AMENDMENT TO FACILITY OPERATING LICENSE

Amendment No. 5
License No. DPR-51

CHANGE NO. 5 TO THE TECHNICAL SPECIFICATIONS

SAFETY EVALUATION BY THE OFFICE OF NUCLEAR REACTOR REGULATION

FIG. NO.
 2.1-2

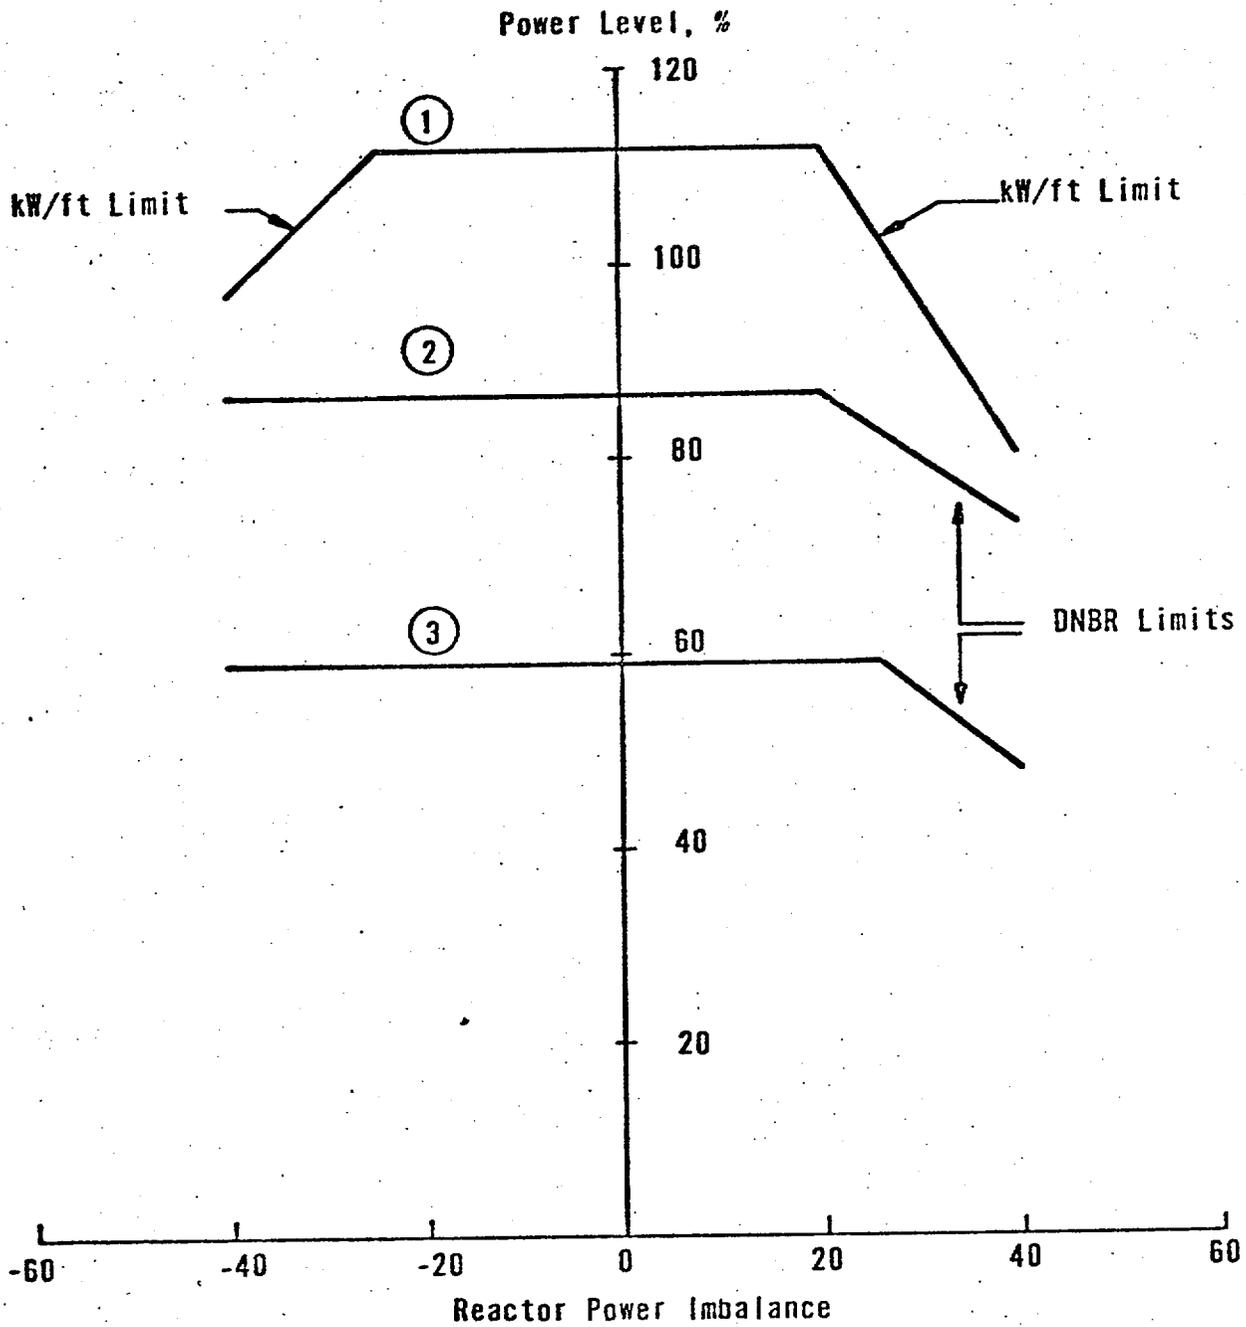
1. Revise the curves in Figure 2.1-2, "Core Protection Safety Limits," to reflect 100 Effective Full Power Days (EFPD) of fuel burnup. This revision involves extensions of the negative and positive imbalance portions of the curves from -17.5% to -24% imbalance and from +19% to +20% imbalance, respectively, and changes in the curve slopes and termination points.
2. Revise the curves in Figure 2.3-2, "Protective System Maximum Allowable Setpoints," to reflect 100 EFPD of fuel burnup. This revision involves extensions of the negative and positive imbalance portions of the curves from -3.98% to -14% imbalance and from +6.08% to +10% imbalance, respectively, and changes in the curve slopes and termination points.
3. Revise Figure 3.5.2-3, "Operational Power Imbalance Envelope," to conform with the extended negative imbalance portion of the proposed Figure 2.3-2.

The existing Figures 2.1-2 and 2.3-2 of the Appendix A Technical Specifications are based on beginning-of-life (BOL) power peaking as the "worst case" condition. The proposed changes would update Figures 2.1-2 and 2.3-2 to take credit for 100 effective full power days (EFPD) of operation. The present core exposure is greater than 150 EFPD. The effect of calculating new curves for Figures 2.1-2 and 2.3-2 based on 100 EFPD is to expand the negative and positive imbalance portions of those curves as well as to change the slopes and endpoints of the curves.

A representative case to be considered is the negative imbalance portion of the upper most curve in Figure 2.3-2. An increase of 10% (nominal) in the negative imbalance of a rodged plant such as Arkansas Nuclear One - Unit 1 will result in an increase in the peaking factor with a consequent increase in the maximum linear heat generation rate of approximately $1.2 \text{ kw/ft}^{1/}$. However, as a result of the burnup of the core to 100 EFPD, the flux is flattened and the peaking factor is reduced. This results in a decrease in the maximum linear heat generation rate of approximately $1.8 \text{ kw/ft}^{2/}$. The net result, considering the situation at 100 EFPD, is that the safety margin is increased by approximately 0.6 kw/ft over its value at BOL. The other proposed alterations in the curves lead to similar net increases in the maximum linear heat generation rate, and thus result in similar increases in the safety margin over those present at BOL. On this basis and the acceptability of the BOL safety margins in our review of the original Technical Specifications, we find that the proposed changes altering the imbalance curves of Figures 2.1-2 and 2.3-2 are acceptable.

FIG. NO.
 2.3-2

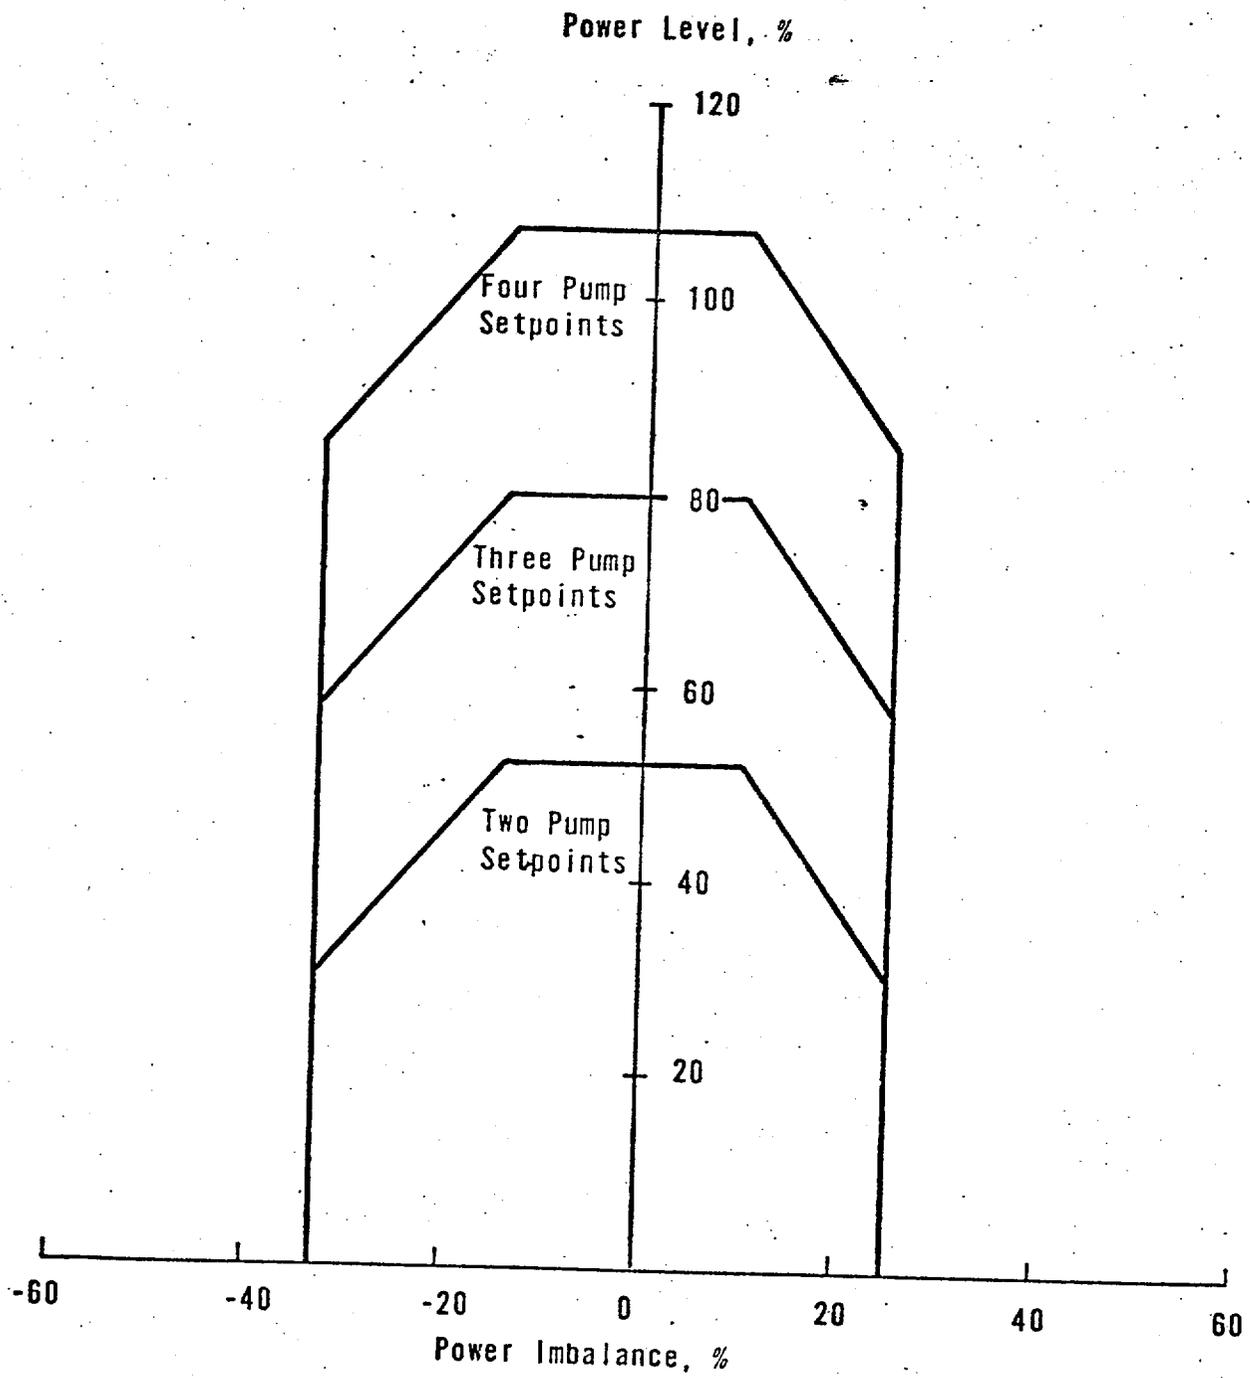
Items 1 and 2 described above are being proposed by AP&L to provide greater flexibility in reactor operation. The setpoints for the "overpower trip based on flow and imbalance" (hereafter called "power/flow/imbalance" trip) are established by the curves in Figure 2.3-2 which are, in turn, based

on the core protection safety limits established by the curves in Figure 2.1-2. The reactor protection system (RPS) is electronically adjusted to make the power/flow/imbalance trip settings conform with Figure 2.3-2. If this setpoint envelope is too restrictive, reactor operation with even small imbalances ($\pm 5\%$) may require a reduction in power level to assure that the reactor does not trip when large load changes occur. An expansion of the curves in Figure 2.3-2 would permit reliable reactor operation at 100% of rated power level.

ARKANSAS POWER & LIGHT CO ARKANSAS NUCLEAR ONE-UNIT 1	OPERATIONAL POWER IMBALANCE ENVELOPE	FIG. NO. 3.5.2-3
--	---	---------------------

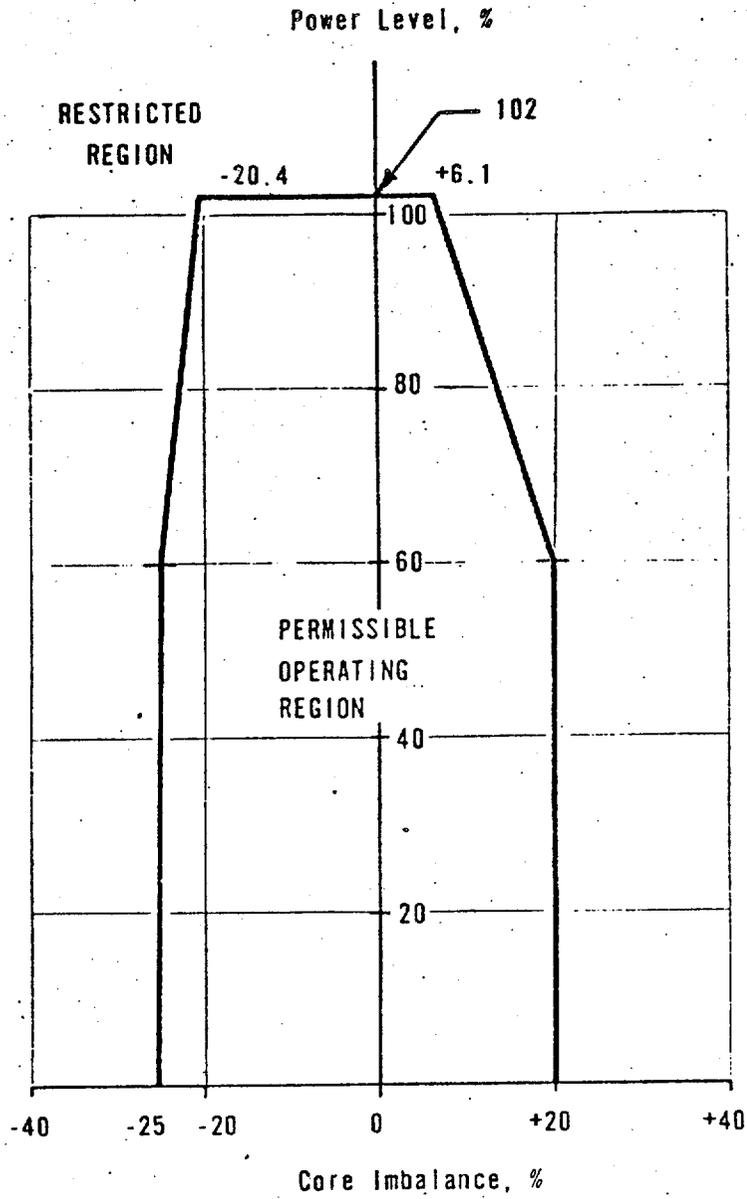
The third part of this proposed change would remove restrictions imposed by the existing Figure 2.3-2 and is consistent with the proposed changes to Figure 2.3-2 discussed above. Figure 3.5.2-3 was altered by Amendment 2 to DPR-51, dated May 9, 1975, from its original configuration which is based on loss-of-coolant accident (LOCA) calculations. The proposed change to Figure 3.5.2-3 would return it to its original configuration thereby reflecting the extended negative imbalance portion of the proposed Figure 2.3-2. Since the original Figure 3.5.2-3 (as it existed before Amendment 2 to DPR-51) previously has been found acceptable by the staff in reviewing the original Technical Specifications, we conclude that the proposed change to Figure 3.5.2-3 is acceptable.
